Combined Total Maximum Daily Load &
Pollutant Reduction Plan

HRG Project No. R004194.0430

WEST GOSHEN TOWNSHIP

WEST GOSHEN TOWNSHIP
Combined TMDL Plan
Public Comments – Margie Swart
August 25, 2017

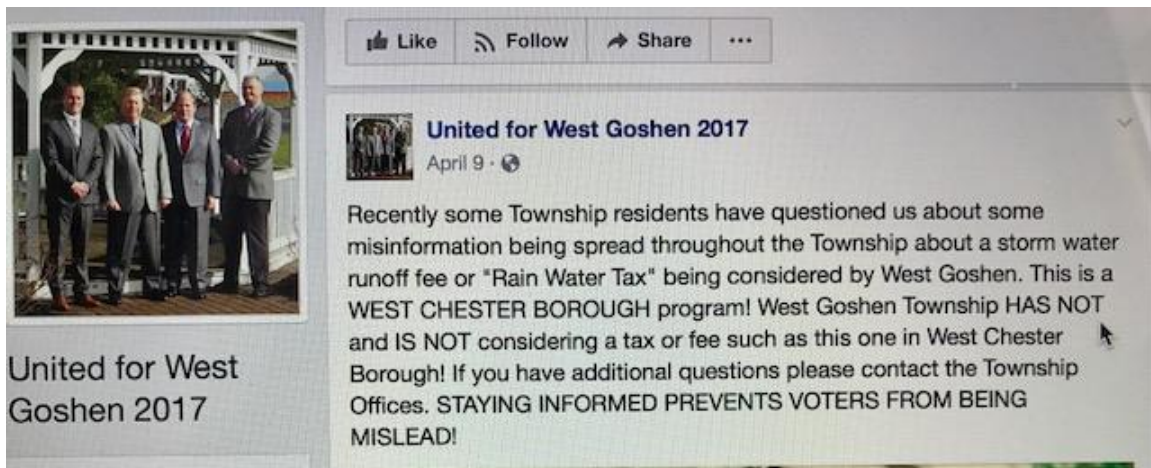
Comment 11. Remove the “collected stormwater fees” as a funding source.

*** Township Supervisors have been adamant, overzealous, and definitive in their public statements about opposition to accessing a storm water fee:

WEST GOSHEN TOWNSHIP
Combined TMDL Plan
ADDENDUM #1
Public Comments – Margie Swart
August 30, 2017

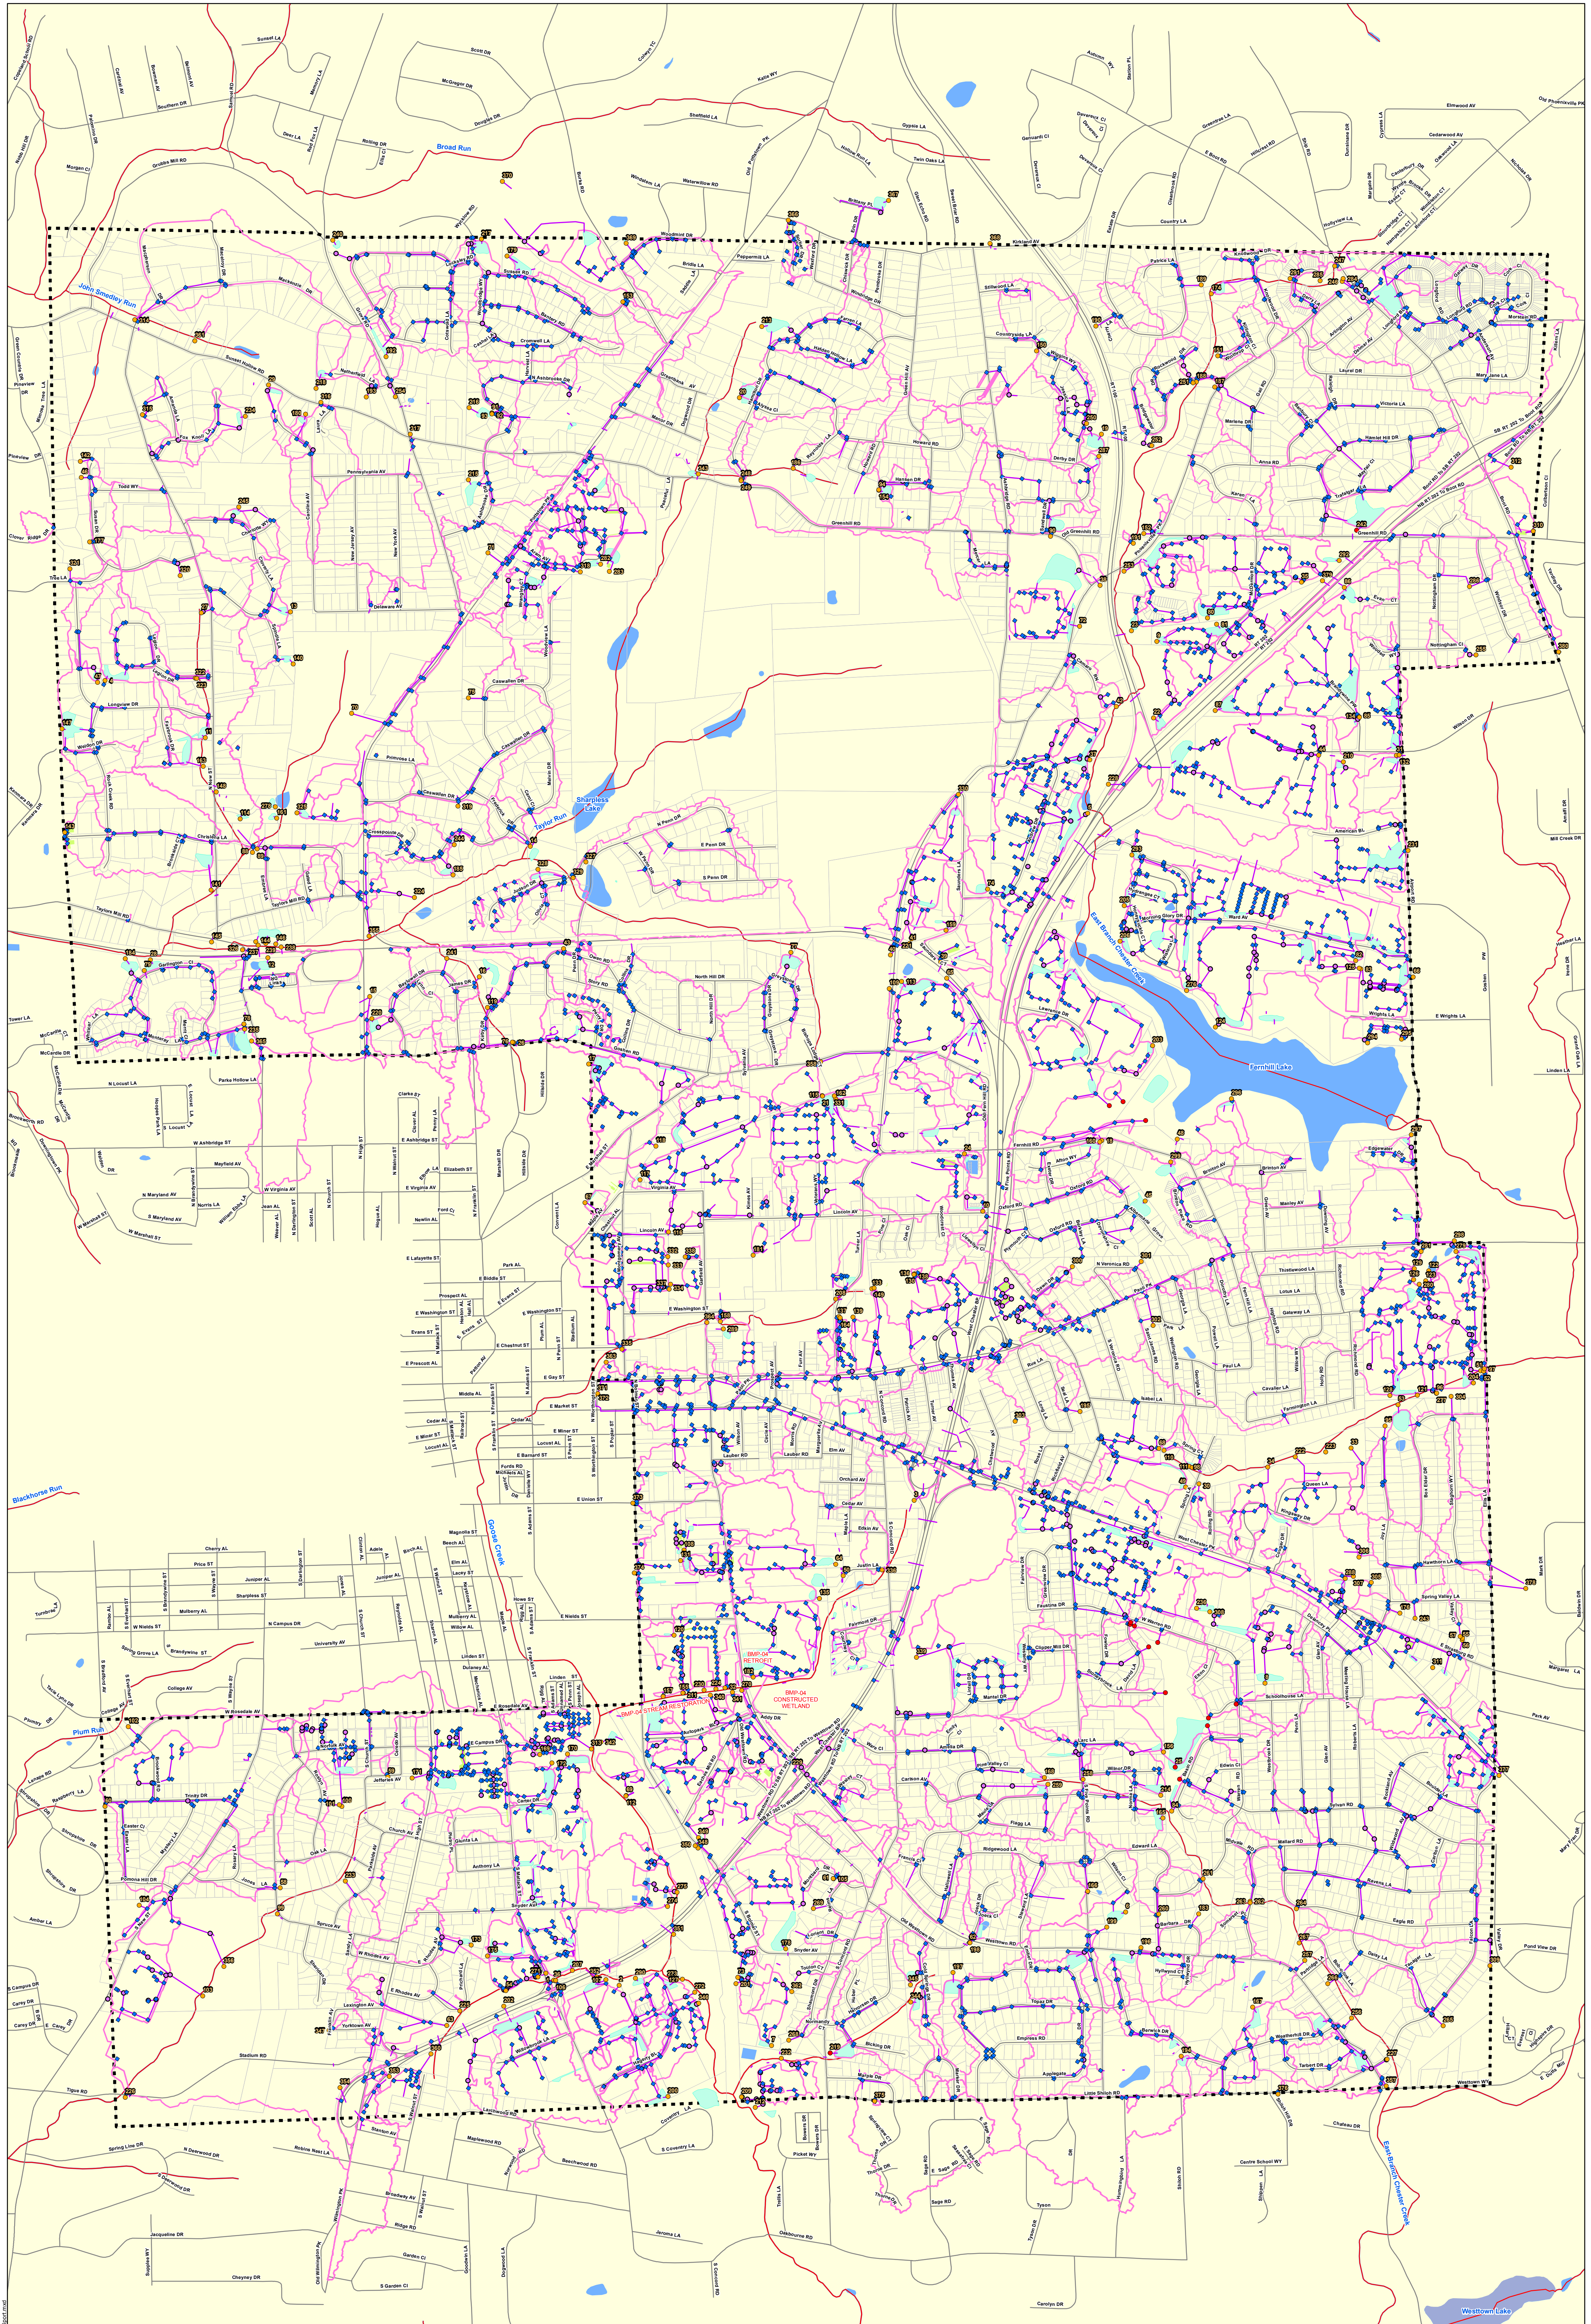
Comment 14. BMP 04, Stream Restoration project, *Westtown Road Stream restoration*.

The 2015 plan included a *Westtown Road Stream Enhancement Project* immediately upstream from the current plan. (Public property on the Chester County Government Services site)

Why did the township eliminate that project and replace it with the current proposed stream restoration that is located on private property?

The private property has its own storm water requirements to meet under PAG - 03 PAR800164 & PAR030034. (Appendix D of proposed plan)

In addition, the township chose to parse this property, along with all other PAG-03 industrial acreage, out of the base load calculations. Accordingly, the township cannot take credit for a BMP located on property that has been parsed out of the *Planning Area*.

The township must have consent of the property owner before it can proceed with a DEP approved plan. The current BMP 04 is estimated to cost more than \$1.3 million. Did the township notify the property owner that it is including this project in their MS4 application? If not, why?

***Response:** Due to the new BMP efficiency credits allotted to streambank restoration, the length of required stream work was reduced and therefore reconsidered. The referenced stream reach was selected based on the current condition of the stream, surrounding vegetation, and proximity to the proposed upstream land-based BMPs, as well as new streambank restoration criteria released by PADEP in June of 2017. Working with private landowners is often required when implementing any type of plan and is an issue that will be addressed during the design and permitting phase. Parsing of adjoining properties does not affect the proposed pollutant load reductions forecasted for the referenced stream restoration project, as the pollutant load reductions are calculated based linear feet of stream, not the drainage area treated. Streambank erosion from the stream reach was not parsed from the Existing Load calculation.*
